**2. CASE 23.074, 41 WHITMARSH STREET, Alfred M. Williams House, c1889 (NORTH ELMWOOD)**

**Proposal:** The scope of work proposed consists of Minor Alterations and includes:

**Issues:** The following issues are relevant to this application:

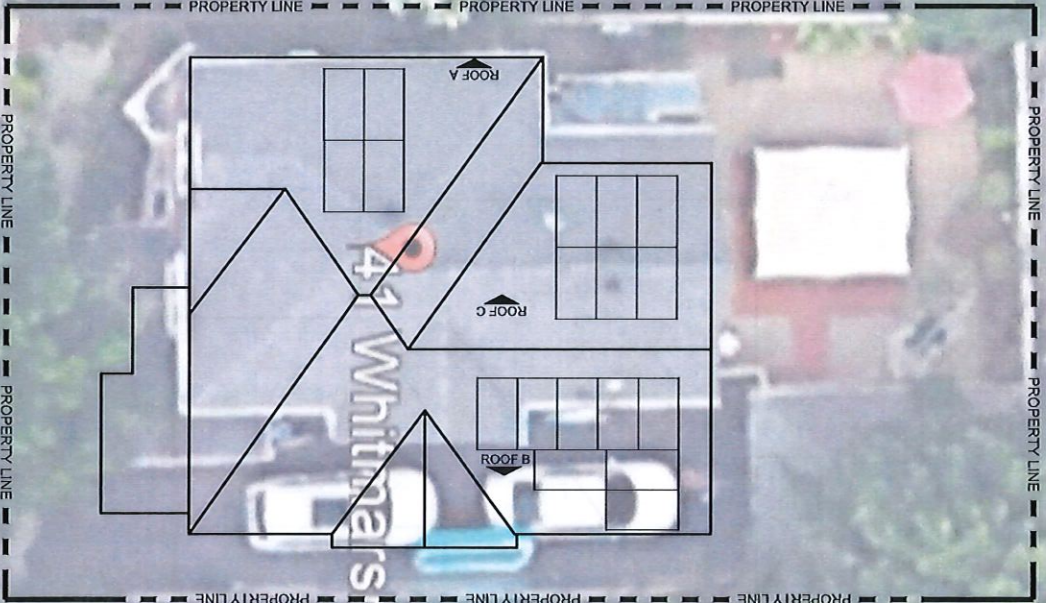
- At the June 26<sup>th</sup> meeting the matter was continued. It was realized that the panels had already been installed. A discussion ensued from which the Commission determined that the application as presented no longer represents the facts and that the matter will be continued with the applicant to return with revised documentation, confirming what had been installed. The Commission also suggested that the panels as in the submitted documentation were highly visible and suggested that the system be redesigned to be less visible from the public rights-of-way;

- Some of the modifications as proposed (roof A) will be (minimally) visible from the public rights-of-way; due to the close proximity to the neighbors it is Staff's opinion that the panels on the west slope will be minimally visible;

- The modifications as proposed meets Minor Alterations: Solar Energy Systems Guidelines, Section 2, in the following manner: Panel layout shall be sympathetic or appropriate to design and scale of building. Rectangular configurations are preferred, with ample setback from edge of roof, dormers, chimneys, etc. (2.A); Panels shall be installed parallel to the existing roof slope and matched as closely as possible to the roof plane (2.B); Panels shall be installed without destroying or replacing original or historic materials or significantly compromising or altering the building's structural integrity (2.C); Panels shall be compatible in color to existing roofing insofar as possible (2.D); Installation of panels shall be as inconspicuous as possible when viewed from public right-of-way (2.E); Installation shall be reversible. Panels shall be removed when no longer viable or functioning and roofing restored to pre-existing conditions (2.F); and,
